TECHNICAL INFORMATION

TI0121

New spiral adjustment for SiLine Snack / SN 48

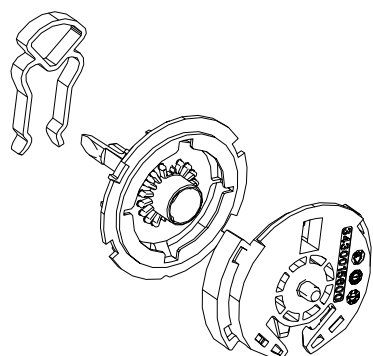
As we continually endeavour to improve our products and quality we have re-designed how spiral adjustments are made in the SiLine Snack and SN 48 vendors.

To remove a spiral, press the mounting clips at the back together.

The loose spiral can now be moved to a different position.

To refit the spiral in its new position, simply push it backwards into the mounting clip, so that it locks into place.

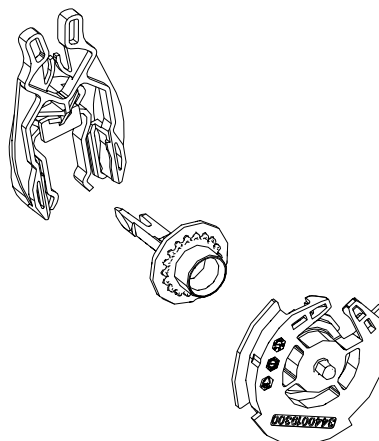
SiClip`n-Turn can be retrofitted. Only three plastic parts must be changed per spiral.

Previous:

343 00 156 00	Plastic wheel at back of spiral
343 00 157 00	Motor coupling
343 00 158 00	Motor fixing

New:

344 00 193 00	Plastic wheel at back of spiral
344 00 192 00	Motor coupling
344 00 194 00	Motor fixing

344 50 192 00	SiClip`n-Turn spiral adjustment kit
---------------	-------------------------------------
